Agenda Date: 12/21/2020

Agenda #: 26. **File #:** 15-14795 **Type:** Zoning Hearing

Rezoning Petition: 2019-037 by Jay Kamdar

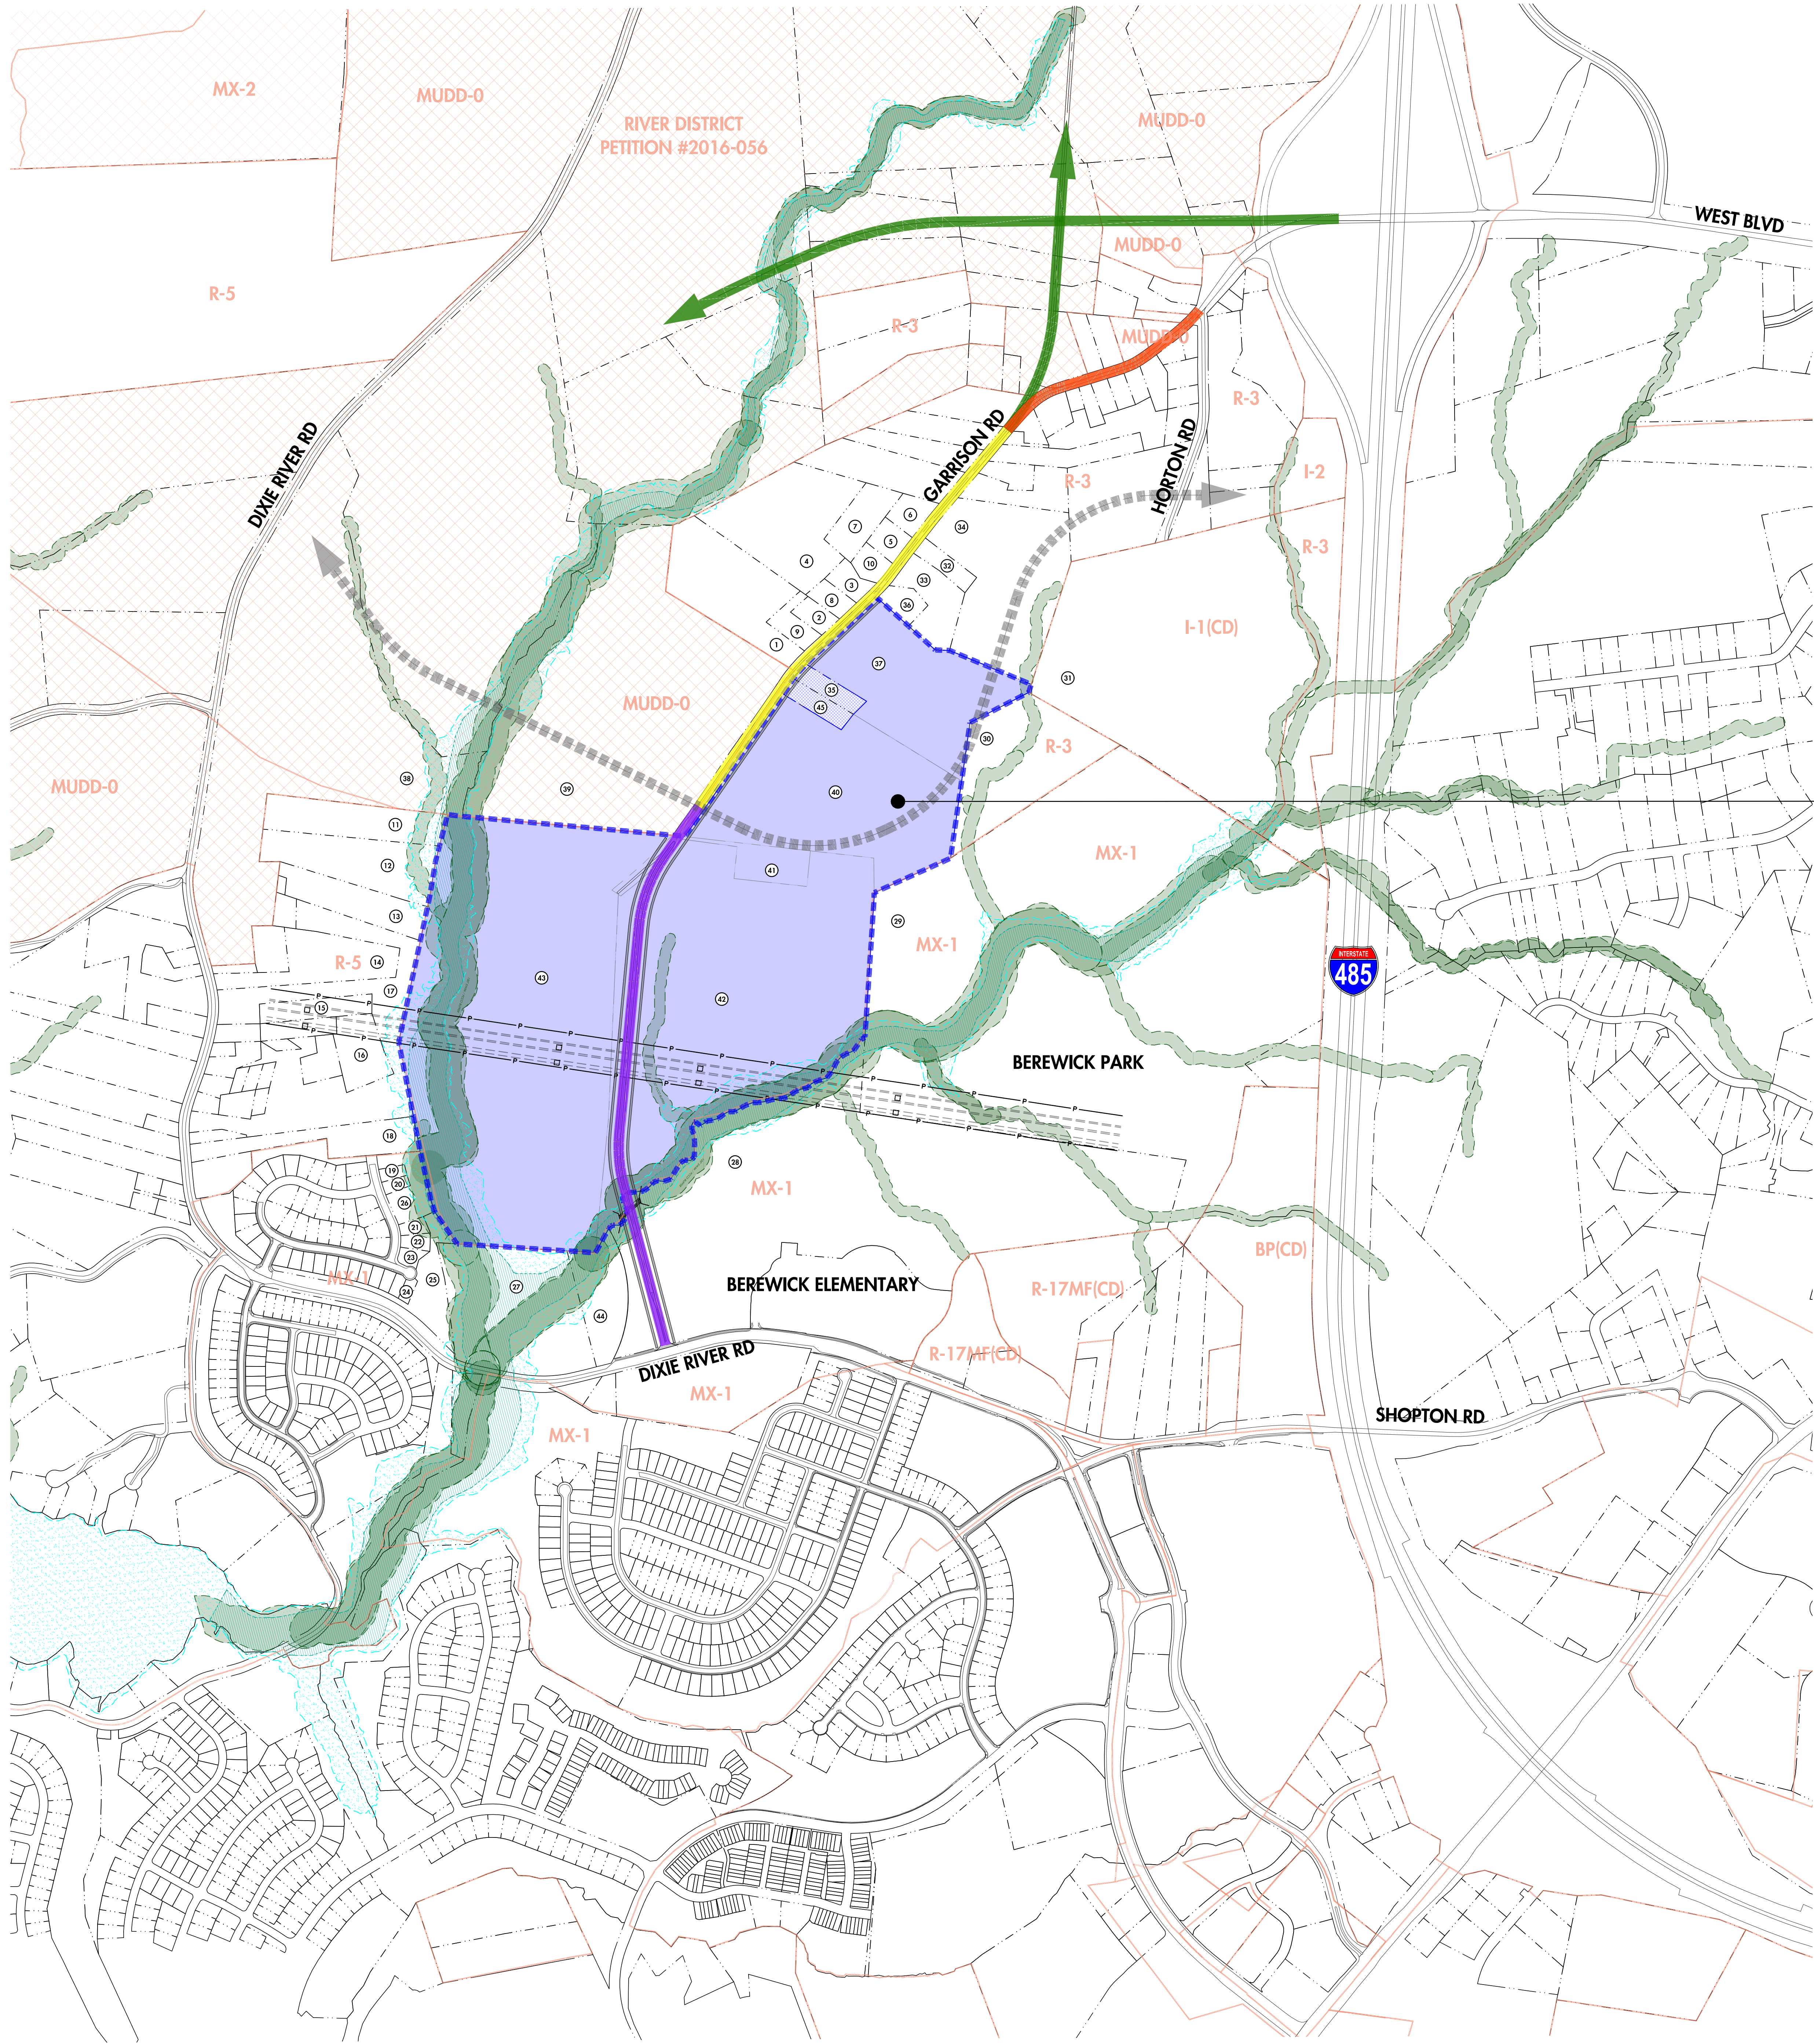
Transportation

1. Add a note stating the final details will be determined during the permit review process to include input from other departments including but not limited to CDOT, General Services, Charlotte Fire Department, and NCDOT. Also include that any applicable ordinance requirements in addition to what is shown on proposed cross-sections may be required.

2. Revise Section B-B to the redlines below, reflecting the latest coordination between CDOT and NCDOT. A three-lane section with a center two-way left-turn lane will provide median space for left turns into the proposed access points for Development Area A. CDOT encourages the petitioner to consider condensing the number of access points for Development Area A on the along the Realigned Garrison Road.

4. Revise the site plan and conditional note(s) to clarify the pavement sections that will be constructed by the petitioner, to be consistent with CLDSM standard detail number 11.09. The pavement schedule, as copied from the West Boulevard Extension plans for the Realigned Garrison Road typical cross sections, are provided below for reference.

6. Revise the site plan and conditional note(s) to commit to constructing left-turn lanes, with the appropriate storage and bay taper, within the center median at the proposed access points for Development Areas B, C, and D within Phase 1. CDOT encourages the petitioner to align opposing driveways and/or condense the number of proposed access points on Realigned Garrison Road, to minimize the number of left-turn lane bays required.

7. Revise the site plan and conditional note(s) to update the proposed road centerline options of the West Boulevard Improvements and Alternative Garrison Road Improvements to Horton Road, per the latest West Boulevard Improvement design that is shown below.

8. Within the scope of the proposed Phase 2 improvements, revise the road centerline dimensions to comply with AASTHO Green Book minimum centerline radius standards for a major arterial.

9. Revise the site plan and conditional note (Section 3.a.(3).b.ii.) to clarify whether the public right-of-way that is required is for the temporary condition (60-ft) or future condition (120-ft).

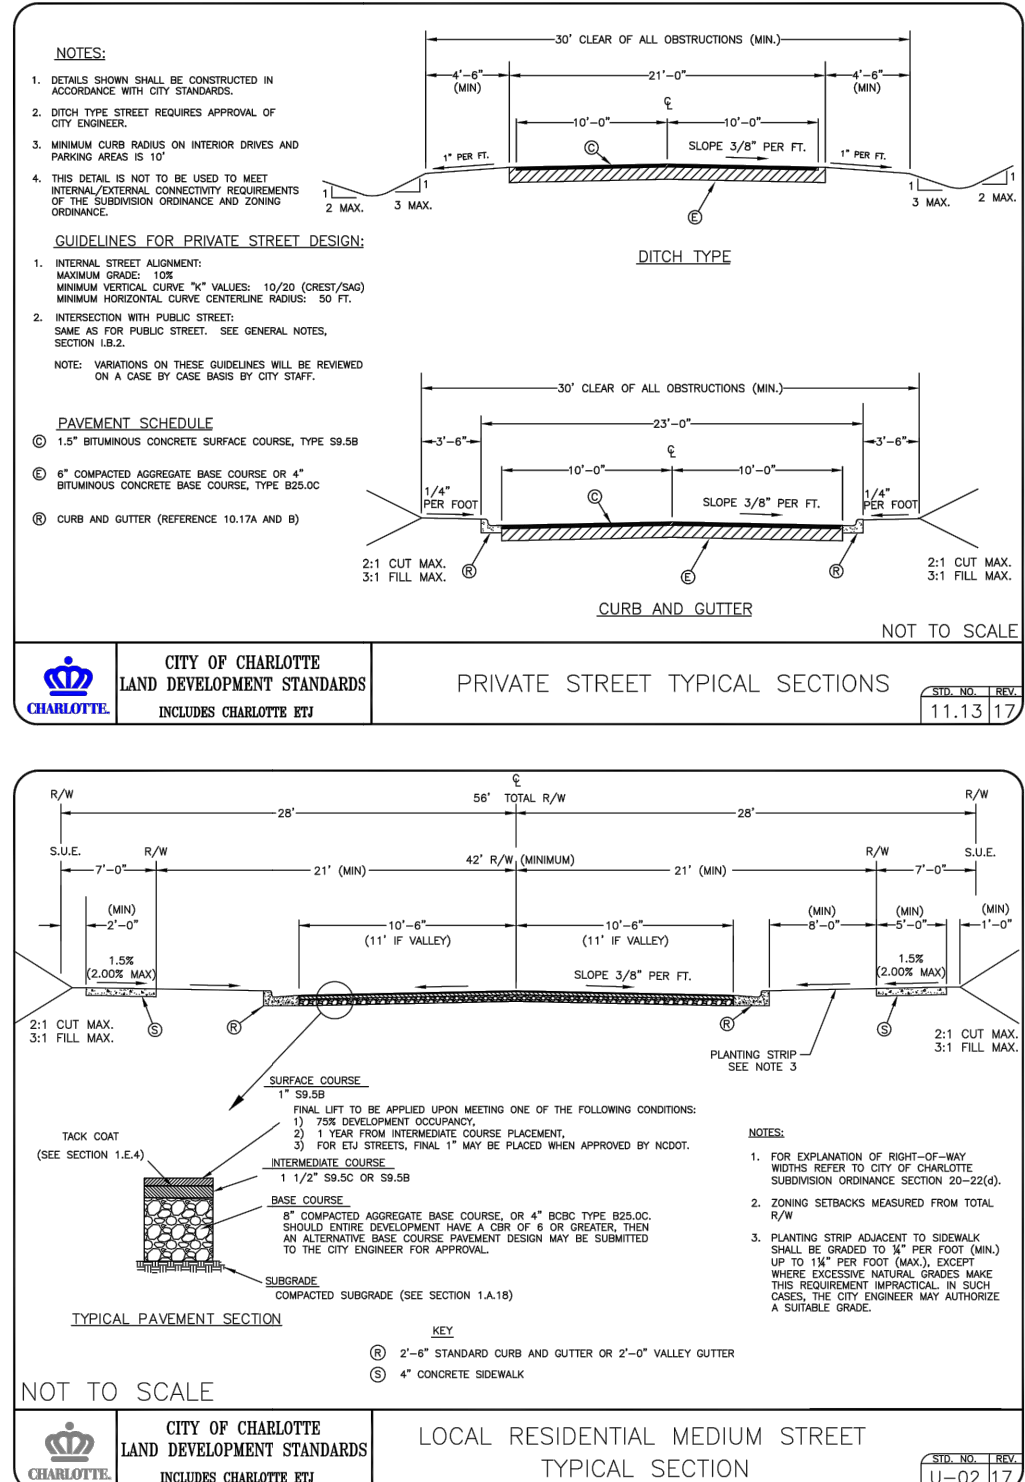
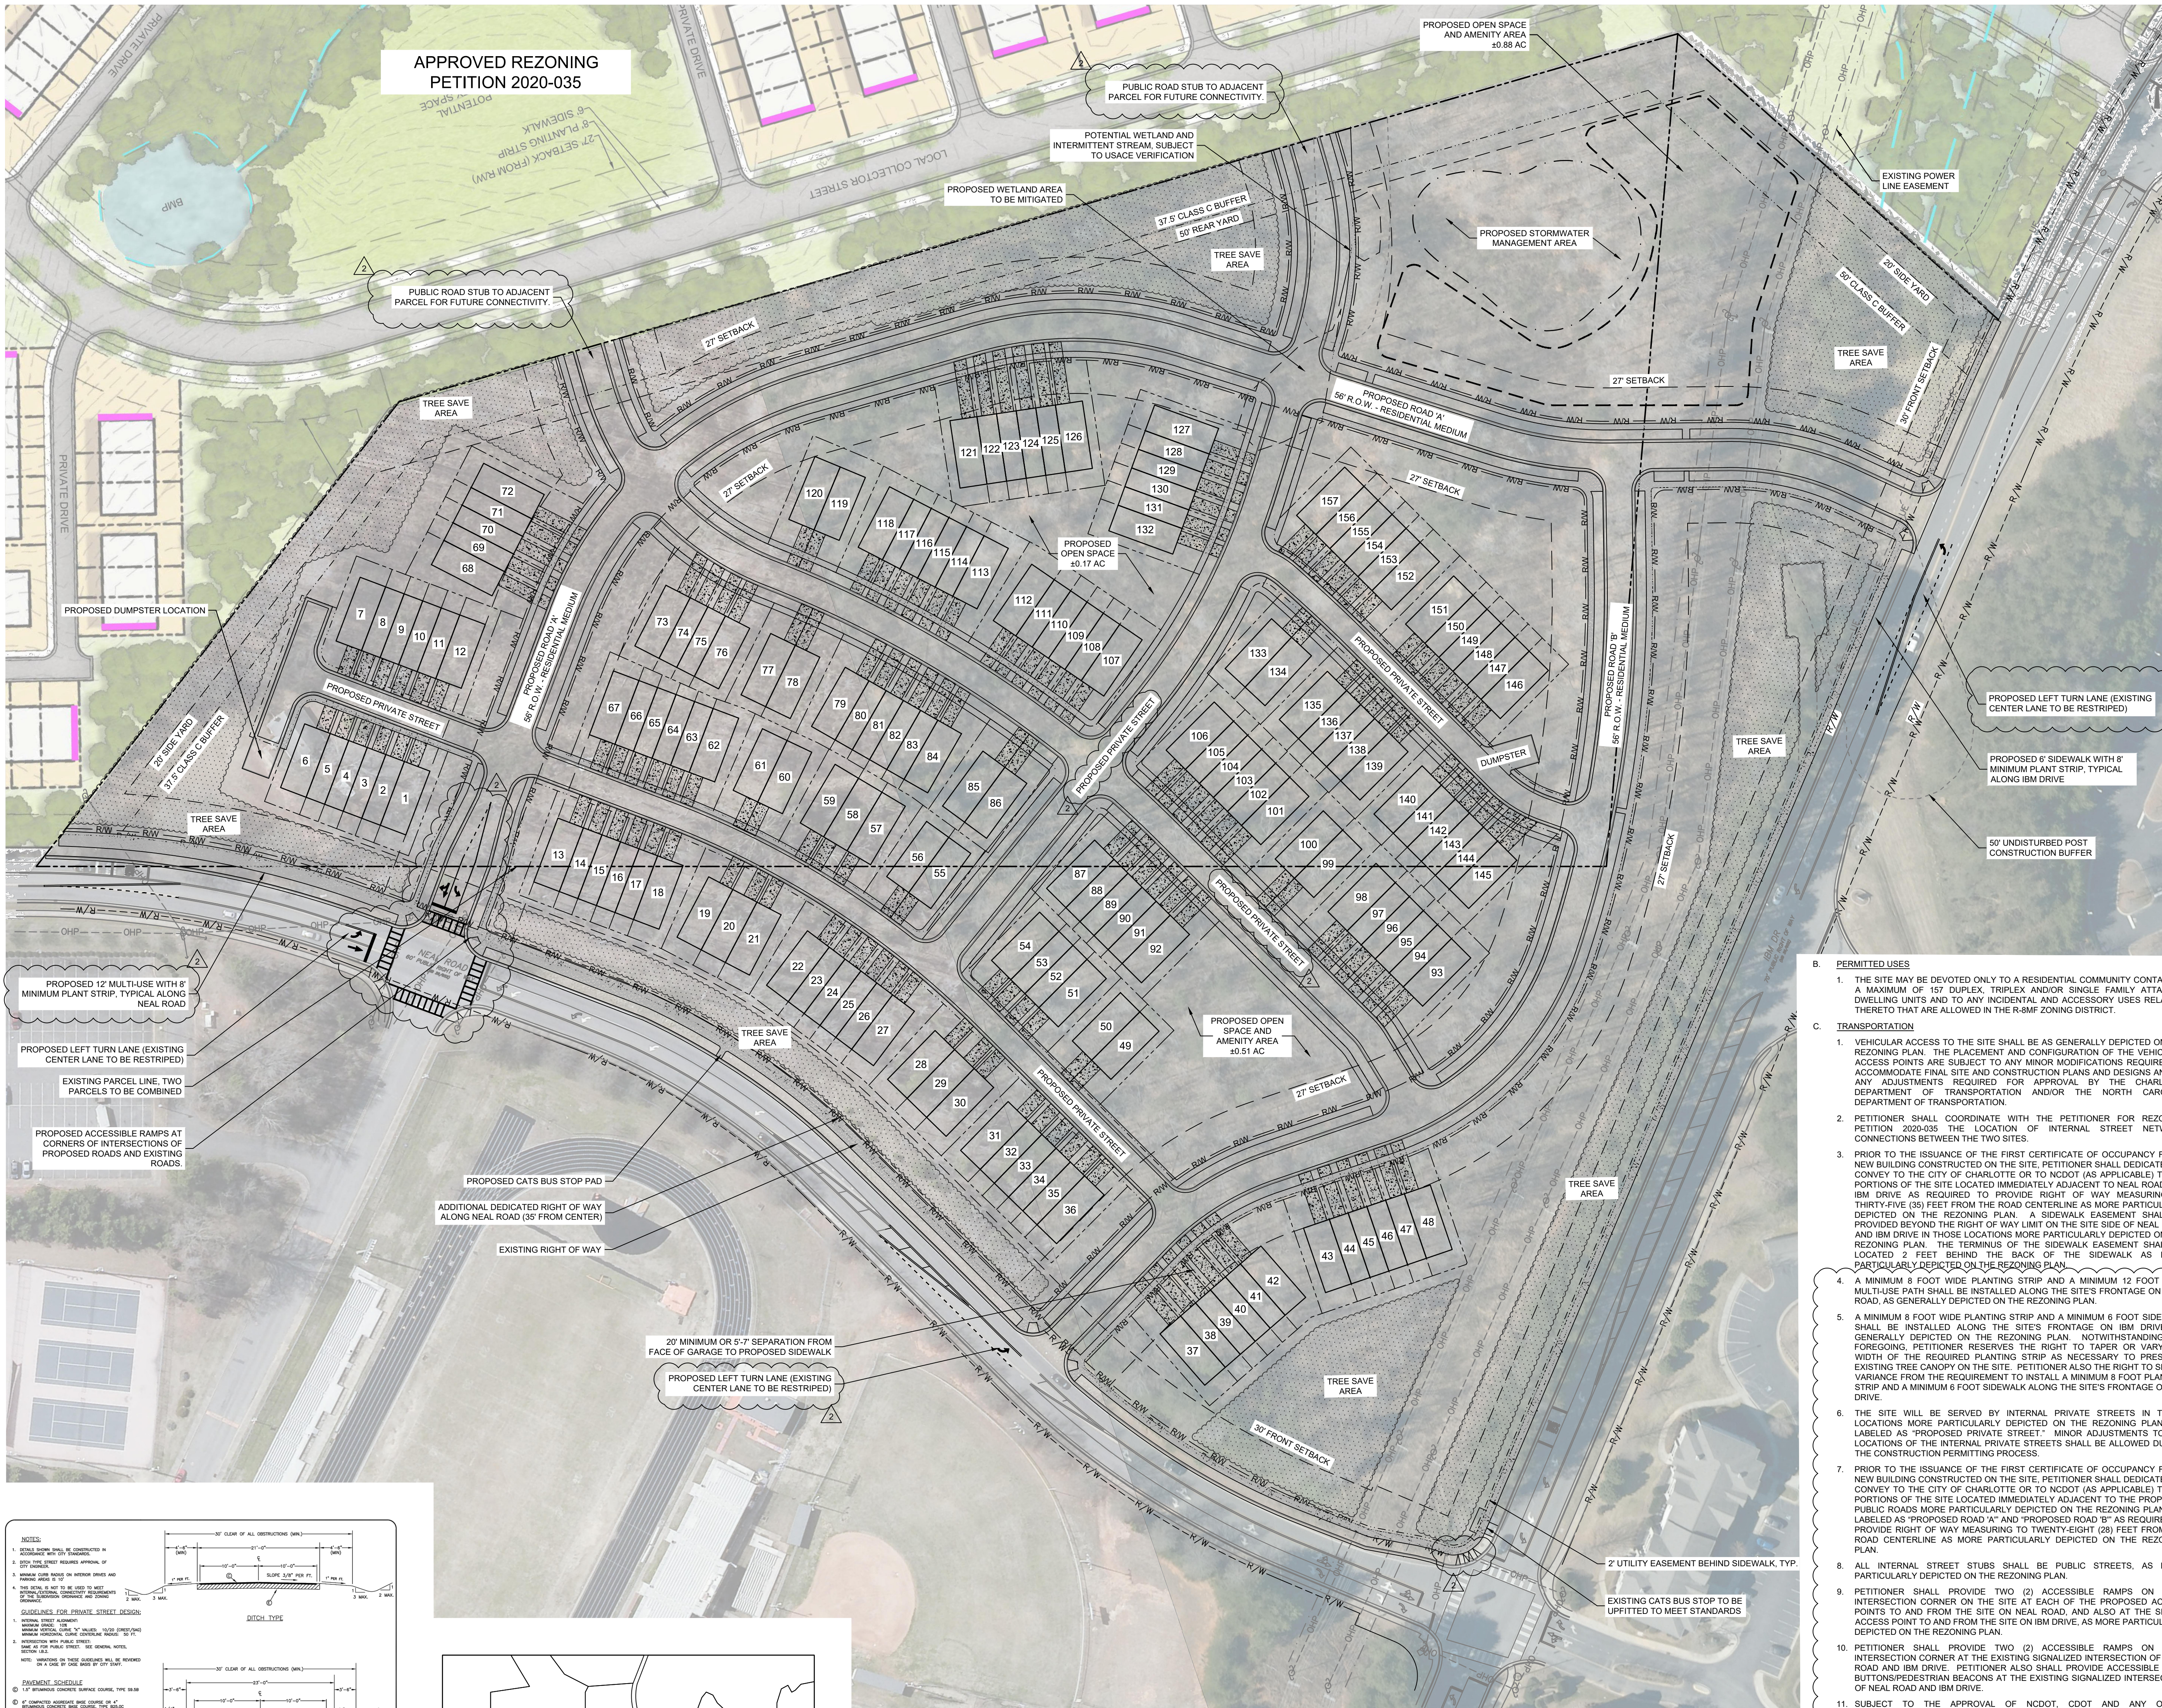
1. This 12-foot MUP and 8-foot planting strip should extend to the intersection of Neil and IBM and along the site's frontage of IBM Drive.
2. Update to Comment as a result of 11-16-2020 Site Plan: Add a conditional note that the signal heads will be included at the Neal Road intersection.

3. New Comment (revised site plan dated 09/14/20) Revise the site plan and conditional notes to re-strip the existing center lane gore striping on Neal Road to accommodate a two way left turn lane, per CDOT's Pavement Marking Guidelines. This re-striping will provide adequate striping for the proposed full movement intersection at Proposed Road 'B' and Neal Road.
